Access Compliance Report Public Rights-of-Way (Pedestrian Signals)

Main Street: CECIL_PASTURE_RD Cross Street: CROWN_VALLEY_PKWY Location: SW

ADA ID: SGRK211026121138 Signal Type: One Push Button-Non APS Overall Compliance: No Severity Scores: BTN 1: 35 BTN 2: N/A No BTN: N/A

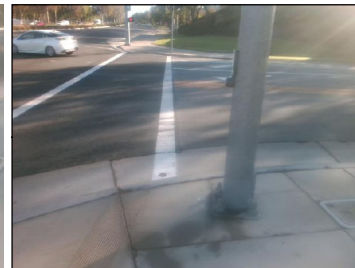
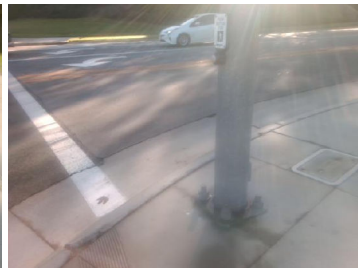
OC Std/PROW: R404.2, MUTCD 4e.08

Possible Solutions: Replace Signal Push Button With APS Button. Remove and Replace Clear Space.
